CITY OF ALBUQUERQUE

**RE: Tract 3A Coors Village
4500 Quaker Heights NW
Revised Grading and Drainage Plans
Engineer's Stamp Date: 11/09/23
Hydrology File: F11D019A**

DRAINAGE AND TRANSPORTATION INFORMATION SHEET (DTIS)

Project Title: Tract 3A Coors Village Hydrology File # F11D019A

TRACT 3A COORS VILLAGE		DRAWN BY
	4500 QUAKER HEIGHTS ABO NM 87120		pm
	GRADING & DRAINAGE PLAN		DATE
			10-11-2023
			2019064_GR-REVISED
			SHEET #
			C2
5571 MIDWAY PARK PLACE NE ALBUQUERQUE, NM 87109 (505) 858-3100 www.tierrawestllc.com		JOB #	2019064

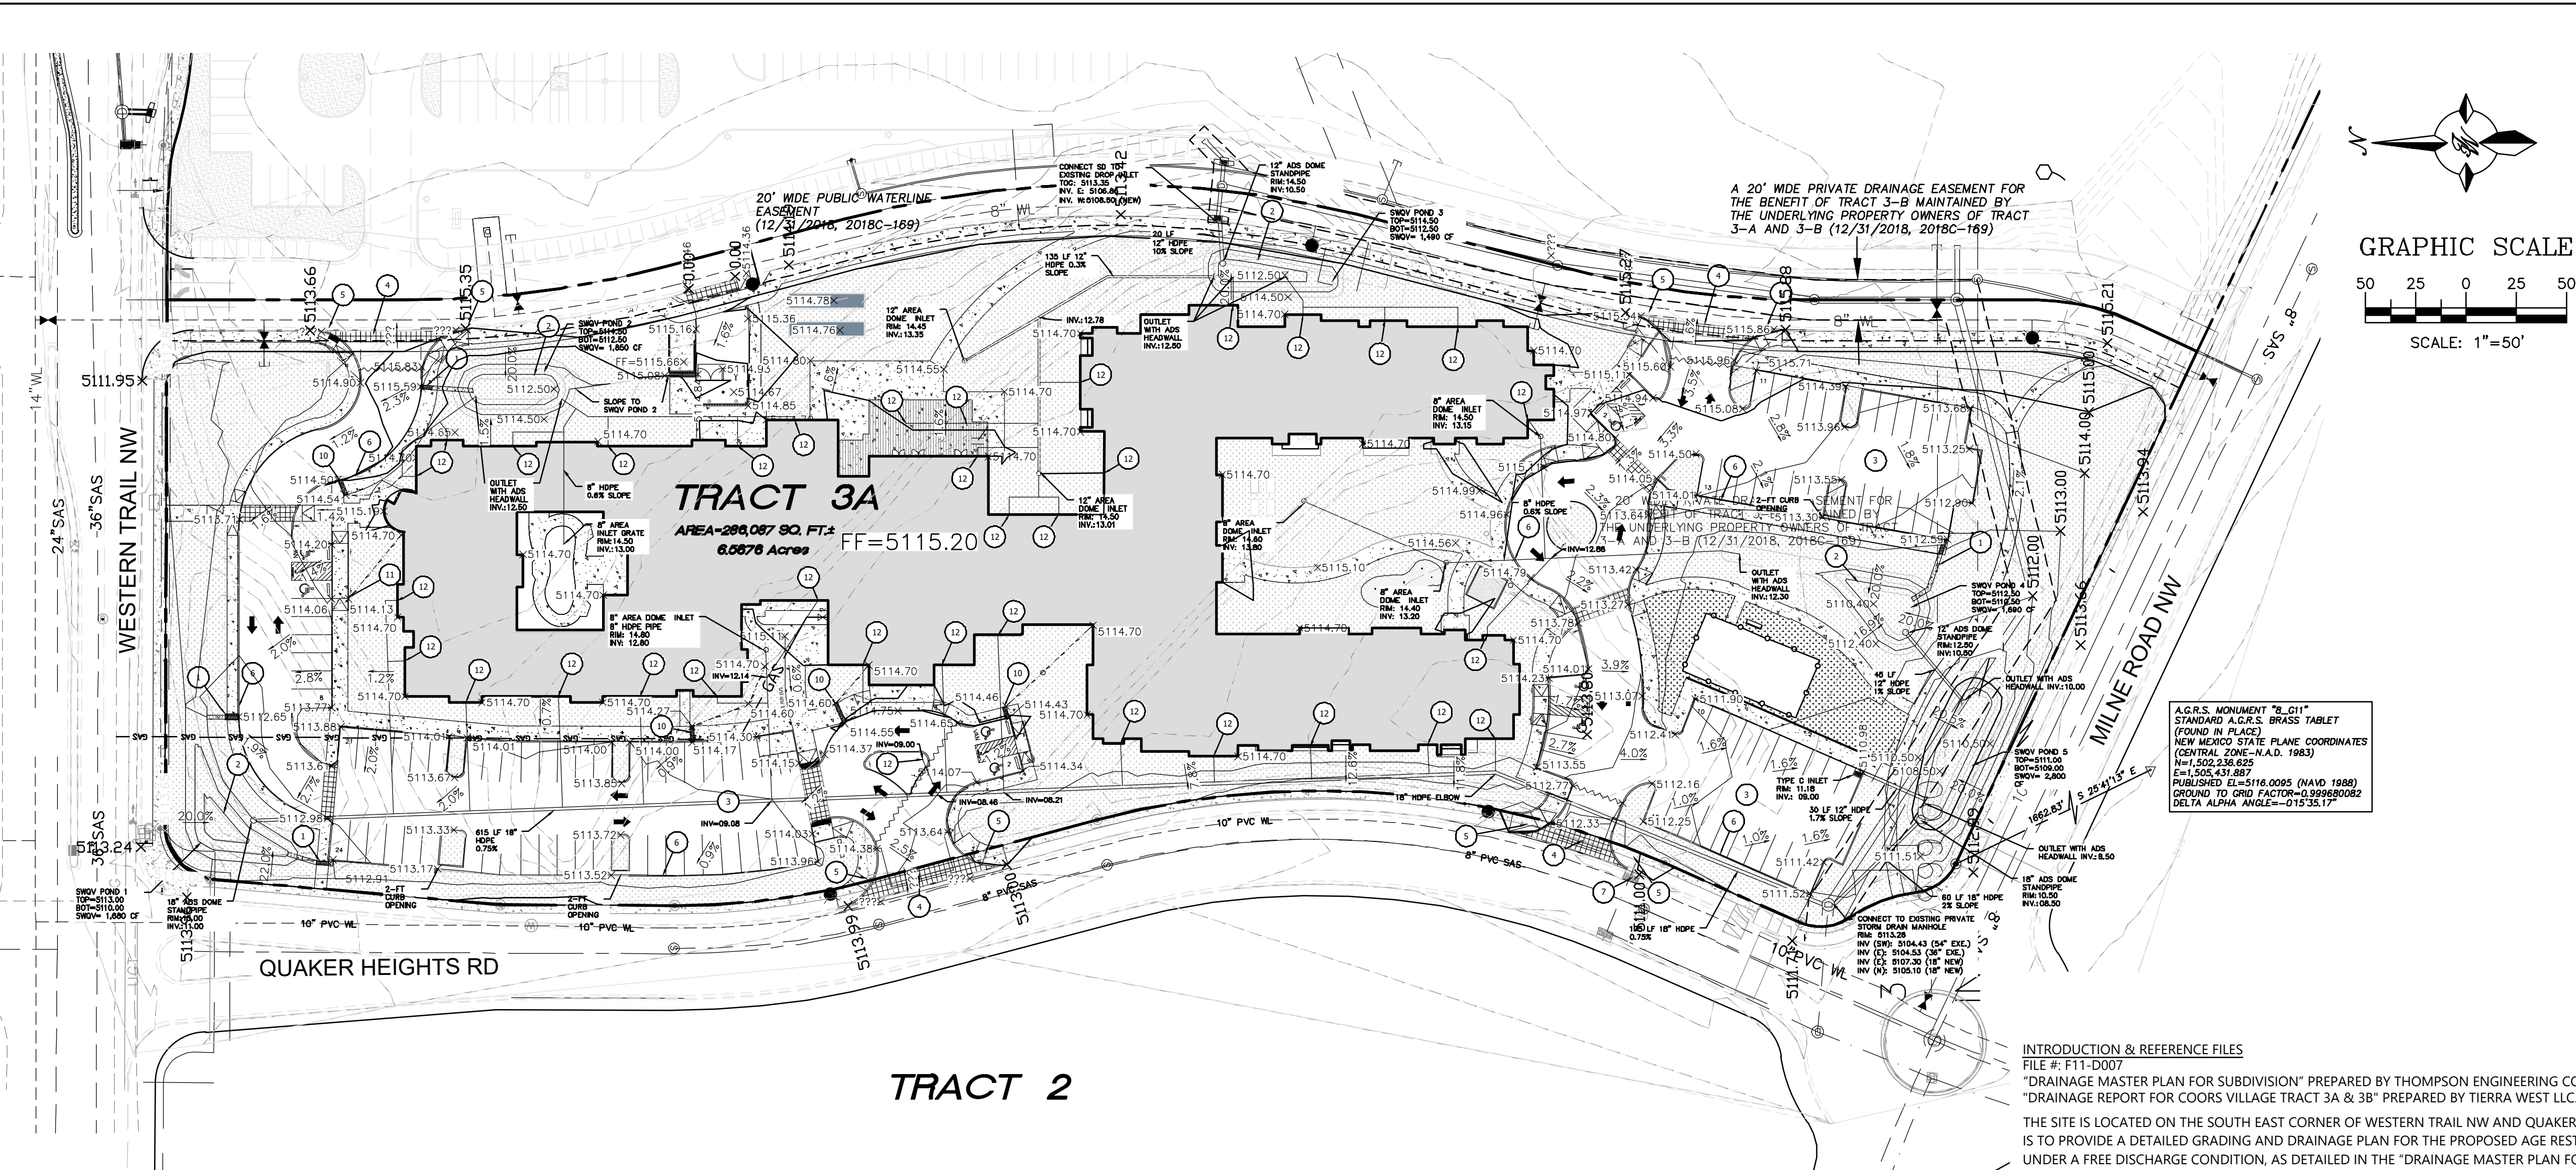
Based upon the information provided in your submittal received 11/09/2023, the Revised Grading & Drainage Plans are approved for Building Permit, and Grading Permit. Please attach a copy of this approved plan in the construction sets for Building Permit processing along with a copy of this letter.

1. Engineer's Certification, per the DPM Part 6-14 (F): *Engineer's Certification Checklist For Non-Subdivision* is required.
2. Please provide the executed paper Drainage Covenant (latest revision) printed on one-side only with Exhibit A and a check for **\$25.00** made out to "**Bernalillo County**" for the stormwater quality ponds per Article 6-15(C) of the DPM to Hydrology for review at Plaza de Sol.
